BCA Design Assessment Report

SCEGGS Darlinghurst – Masterplan 2040
215 Forbes Street,
Darlinghurst

Project: SCEGGS Darlington – Masterplan 2040
 Document Type: BCA Design Assessment Report
 Report Number: P218_153-2 (BCA) LS

Figure 1 – Firewall location which separates the Wilkson Building from the Centenary Sports Hall

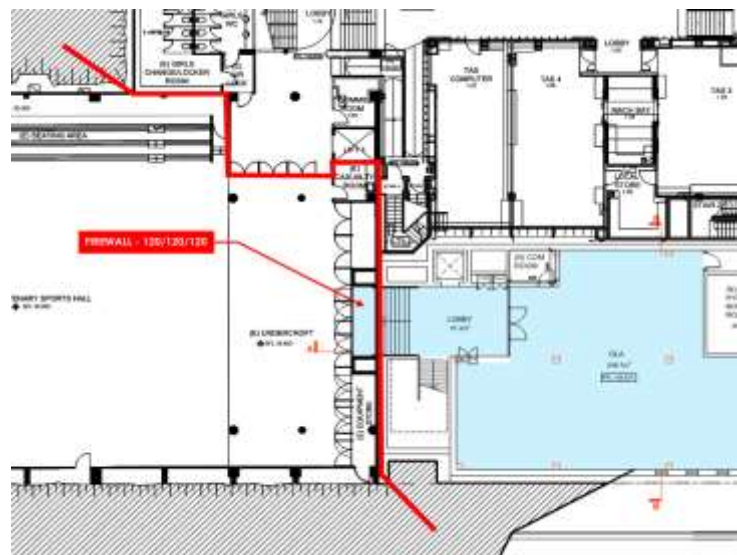
Cl. C2.2	To ensure the subject building is within the maximum floor area and volume limitations prescribed within C2.2, the building is to be separated from the adjoining building known as a the Centenary Sports Hall.
-------------	--

Compartmentation is to occur at every level, refer to Figure 1 below.

C2.7	<p>As stated in C2.2 above a fire wall needs to be introduced at all levels the buildings share a common wall or the like.</p> <p>Be advised that the DTS requirements of the BCA require the subject wall shown in Figure 1 to be constructed as follows –</p> <ul style="list-style-type: none"> (i) The passive / solid walls located between the two compartments is to achieve an FRL of not less than 120/120/120 and extend uninterrupted from the slab to slab; (ii) The doorway / opening which permits persons to pass through is to via a self-closing fire-rated doorsets that is tested to achieve an FRL of --/120/30
C2.10	<p>The lift shafts are required to achieve an FRL of 120/120/120 or --/120/120 (if non-loadbearing).</p>
C2.11	<p>The stairway and passenger lift proposed within the lobby connect five storeys (basement to level 3) and therefore are required to be fire-isolated and located in separate shafts.</p> <p>The proposal currently shows the subject stairway and lift in the same shaft and whilst the lift is located within a shaft which can be fire-rated appropriately the stairway is not enclosed / fire-isolated.</p> <p>The stairway design is discussed further in clause D1.3, however the current design may be capable subject to a performance based approach be adopted.</p>

C3.5	<p>As discussed in C2.2 and C2.7 above a fire wall needs to be introduced at the lower ground floor level to divide the building into two separate compartments and any opening located within this wall is be a self-closing fire door which achieves an FRL of --/120/30.</p>
C3.10	<ul style="list-style-type: none"> (i) The doorways providing access to the lift shaft shall be protected by --/60/-- fire doors complying with AS1735.11-1986 and remain closed except when discharging or receiving passengers or goods; and (ii) Any lift call button, indicator panel or other panel located within the wall of the fire-isolated lift shaft must be backed by construction having an FRL of --/60/60 if it exceeds 35,000mm² in area.
Cl. C3.12	<p>Where a service passes through a floor required to achieve an FRL, that service is required to be protected by either a shaft which has been construction in accordance with BCA Spec C1.1 (listed above) or in accordance with C3.15 (see below).</p>
